5. ASSESSMENT OF ENVIRONMENTAL IMPACTS

5.1 FLOODING AND CLIMATE CHANGE IMPACTS

Figure 9. *Intersection of Wrexham Road and Lawrence Hargrave Drive & Extent of Road Upgrade Works*

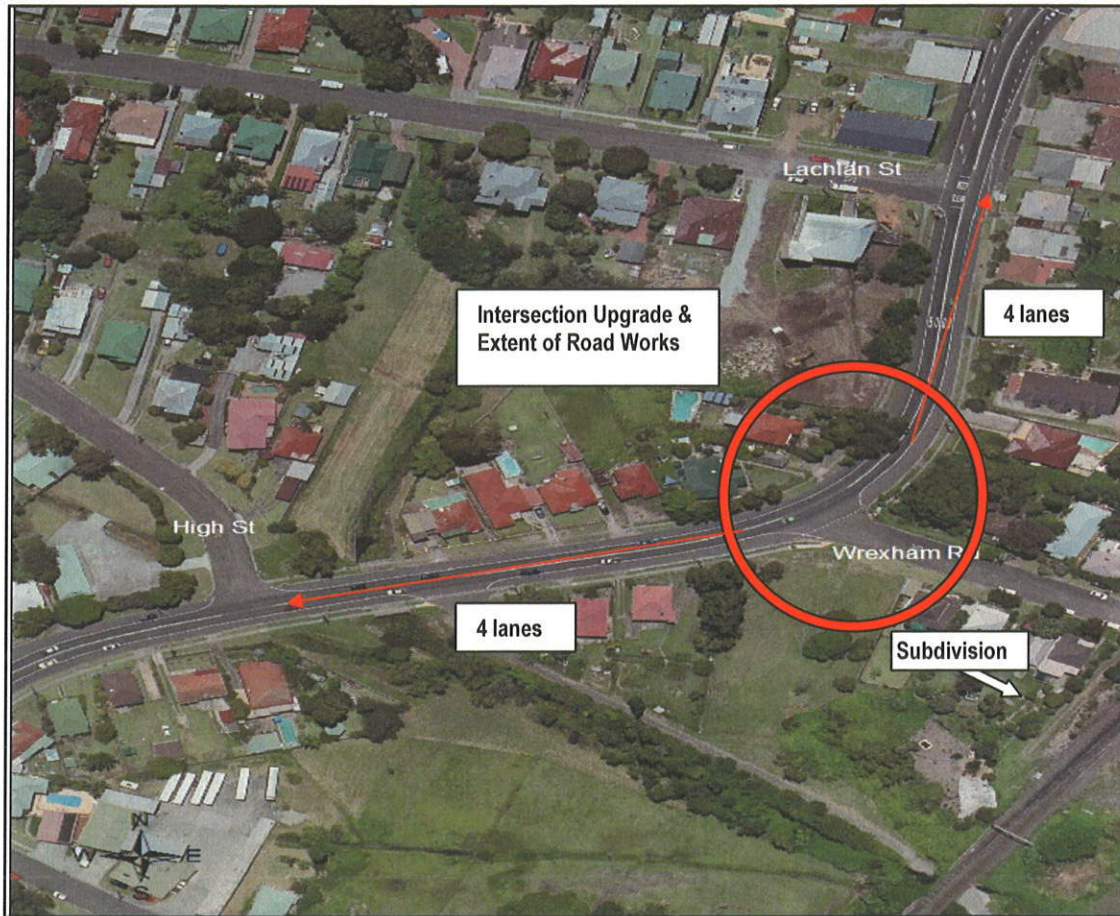
The RTA reviewed the proposed upgrade works and required further analysis of the impact the development will have upon the intersection of Lawrence Hargrave Drive and Wrexham Road (**Figure 10**). They were concerned with the availability of appropriate sight distance for vehicles turning right into Wrexham Road from Lawrence Hargrave Drive, as there is potential for direct conflict with through southbound vehicles creating a safety concern.

The RTA have maintained their concerns in relation to right turning movements from Lawrence Hargrave Drive into Wrexham Road, particularly with the future impacts associated with allowing this movement on road safety and traffic efficiency in the precinct. To address this issue, the RTA recommended conditions of approval including:

- *Submission of a plan demonstrating that Lawrence Hargrave Drive can be upgraded to four lanes between High Street and Lachlan Street; and*
- *Lawrence Hargrave Drive to be upgraded to four lanes (between Lachlan Street and High Street) and Wrexham Road to be upgraded to allow three lanes and traffic signals and lighting installed prior to any traffic accessing the proposal.*

- *Wrexham Road shall be upgraded to allow three lanes (two westbound, one eastbound). The pavement on Wrexham Road shall be suitably upgraded to accommodate the traffic signal infrastructure.*

- *Traffic signals shall be provided at the junction of Lawrence Hargrave Drive (MR 185) and Wrexham Road. The traffic signals shall be constructed as a three-phased arrangement.*

- *Lighting shall be provided at the junction of Lawrence Hargrave Drive (MR185) and Wrexham Road in accordance with Australian Standard AS/NZS1158.*

The Department has considered the Proponent's response and, given the Proponent's modelling suggests that queue lengths of 175m and 196m in the morning and evening peaks may occur, considers that the upgrade of Lawrence Hargrave Drive to four lanes between Lachlan Street and High Street is reasonable. While not all of the traffic that will be queuing up along this distance will be directly attributable to the new subdivision, the proposal does require the upgrade of the intersection at Wrexham Road which in turn will require the upgrade of the roads leading up to this intersection. Given the distance of expected queuing and the fact that the new development will add to the traffic demands along this road, the Department considers that the upgrade of Lawrence Hargrave Drive to four lanes between Lachlan Street and High Street is a reasonable request.

Further, that given the safety concerns of the RTA, the recommended timing of the works is acceptable and should be in place prior to construction traffic accessing the site via Wrexham Road. The Department has considered the issues

raised by the RTA and supports the addition of the recommended conditions to ensure an appropriate outcome for this intersection.

Figure 10. Lots without direct street access (blue diamond) and Precinct 2 townhouse lots rear laneway (in blue circle)

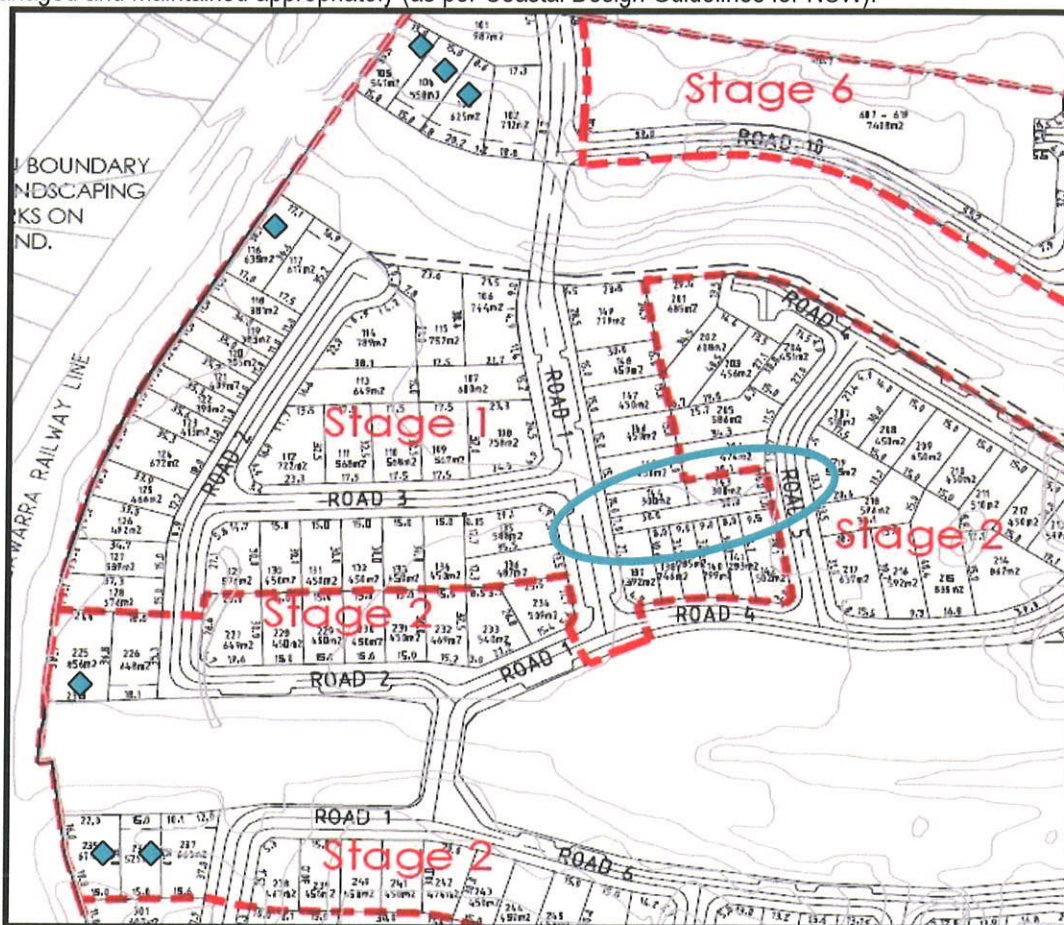
The Department and Council raised concerns regarding access where lots do not have street frontage and are accessed by an easement across other properties or via a narrow handle in the case of battle-axe lots. Where houses do not have direct access to the street there are concerns regarding safety and surveillance and the ongoing maintenance and management of the access easements. A total of 7 lots do not have direct street access as illustrated in **Figure 10** below.

These lots represent a minor proportion of the overall development. They front the riparian corridors and will have an area of defensible space including an eco-trail at the front of the property, which will allow for natural surveillance and emergency access to the properties. However, the Department considers that each allotment should have direct access to the street for safety and access reasons and recommends a condition of approval.

The access lane to the rear of townhouse lots in 'Precinct 2', fronting Road 4 and Woodlands Creek, is proposed to be managed as a right-of-way with reciprocal rights to access each lot. The Department recommends the creation of a

formal public laneway for vehicular access to the rear of these lots with subsequent dedication to Council to ensure this lane is managed and maintained appropriately (as per Coastal Design Guidelines for NSW).

Figure 11. Lot access affected (blue diamond) by the Probable Maximum Flood level (dashed red line) (excerpt of 'Post-development Flood Extents for Hewitts and Woodlands Creeks' Drawing no SK07 Rev P2- 28/10/08 by Cardno Forbes Rigby)

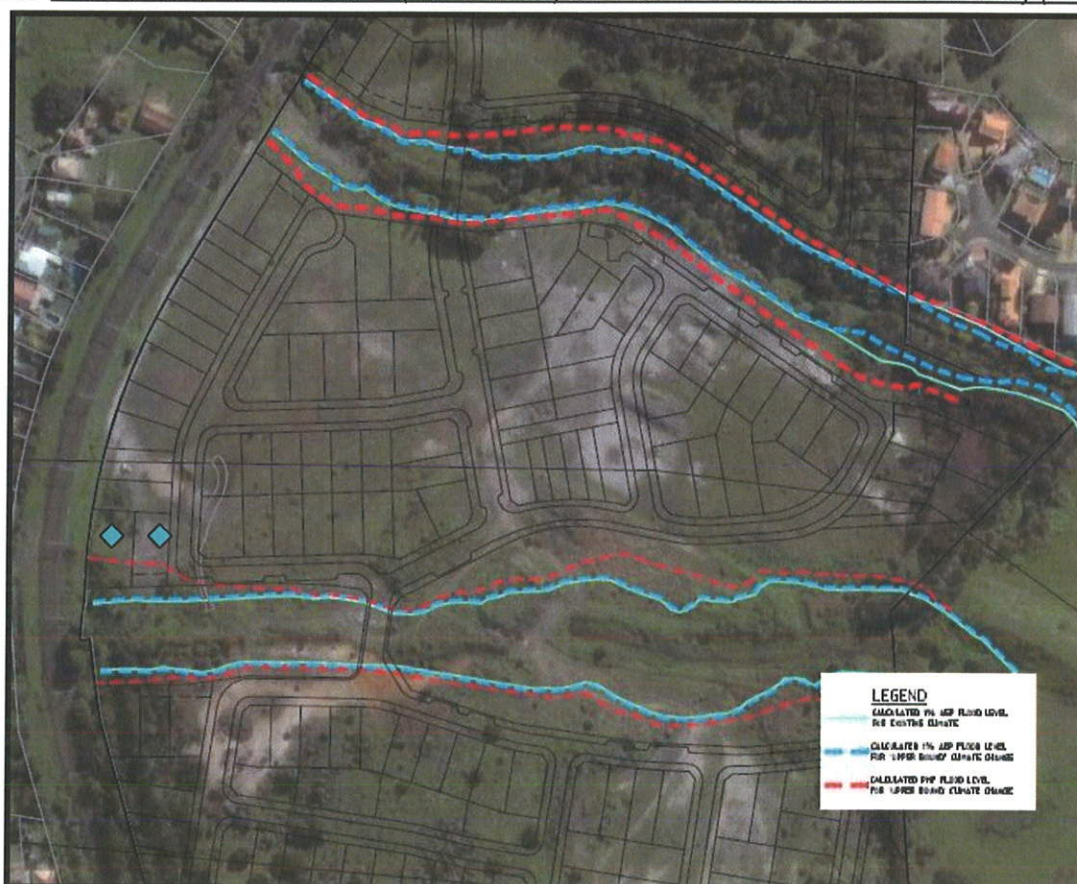
It is also recommended that the access for the lot adjacent to the railway lane on the north side of Woodlands Creek (lot 225) be moved to the northern side of the property to ensure it is outside the Probable Maximum Flood (PMF) level identified in the drawing titled 'Post-development Flood Extents for Hewitts and Woodlands Creeks' no SK07 Rev P2 (**Figure 11**).

Figure 12. Lots (purple line) partly outside the development footprint (black line) [Note: underlying zoning shown is as proposed in MD SEPP Amendment]

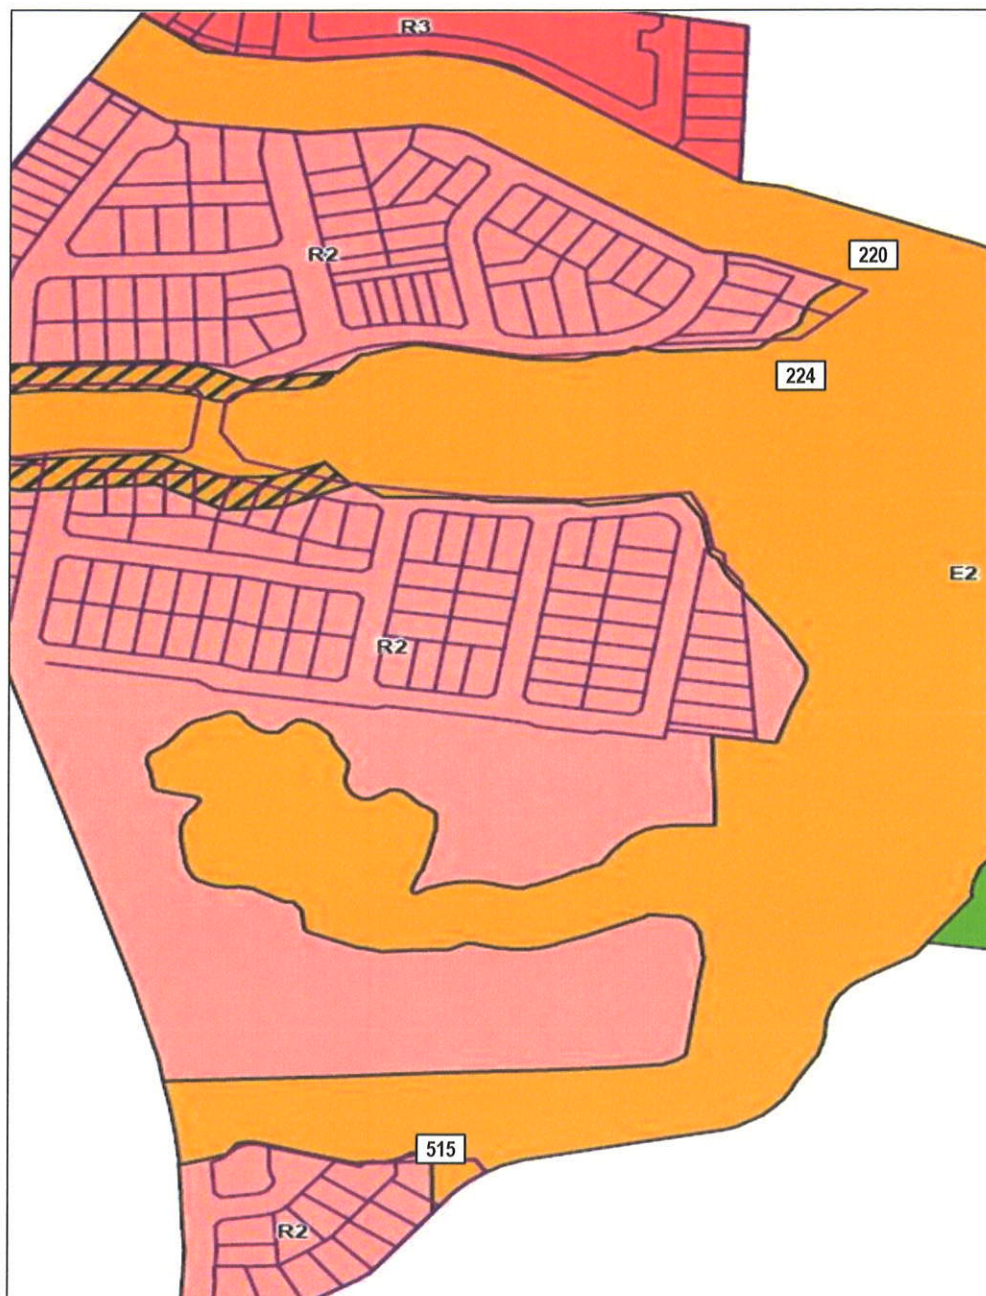
The subdivision layout in the EA report included 3 lots (220, 224 and 515) that are partly outside the development footprint approved by the Concept Plan, as illustrated in **Figure 13** below. The Proponent explained that plans utilised were not totally accurate in reflecting the development footprint and indicated will accept a condition of approval to rectify this error. It is recommended that a condition of approval be imposed requiring the Proponent to submit revised plans that address this issue to ensure all lots are within the approved development footprint.

Figure 13. Indicative areas (black) to be covered by sample test excavation (stippled area outside current subdivision, blue area also has potential for non-indigenous heritage)

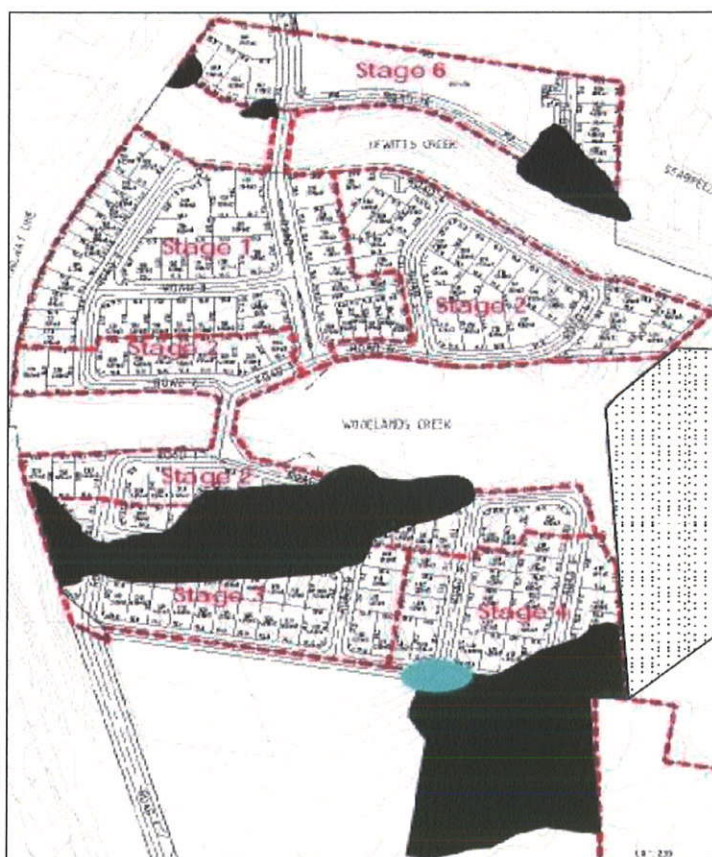
The Proponent's heritage consultant has prepared a Desktop Assessment of Archaeological Potential (see **Appendix B**) that has recommended areas for precautionary testing (**Figure 14**) to be undertaken where they consider there is some potential for the land to contain Aboriginal objects. The report also includes a Heritage Interpretation Plan for the site that outlines themes and interpretive features for the site and establishes the appropriate means of recording or storing artefacts from past uses of the site.

- Sample test excavation shall be carried out in the areas identified in Figure 6 of the 'Desktop Assessment of Archaeological Potential' (prepared by Susan McIntyre-Tamwoy Heritage Consultant April 2007), prior to commencement of works. All Archaeological Investigations must be done in consultation with the Aboriginal community as outlined in the Statement of Commitments.
- If any relics are uncovered at any stage or if any works disturb Aboriginal cultural materials, all work shall cease immediately and the relevant organisations contacted.
- Inform those engaged in earthworks of the requirement to obtain consent from DECC prior to knowingly destroying, defacing, damaging a relic or Aboriginal place.
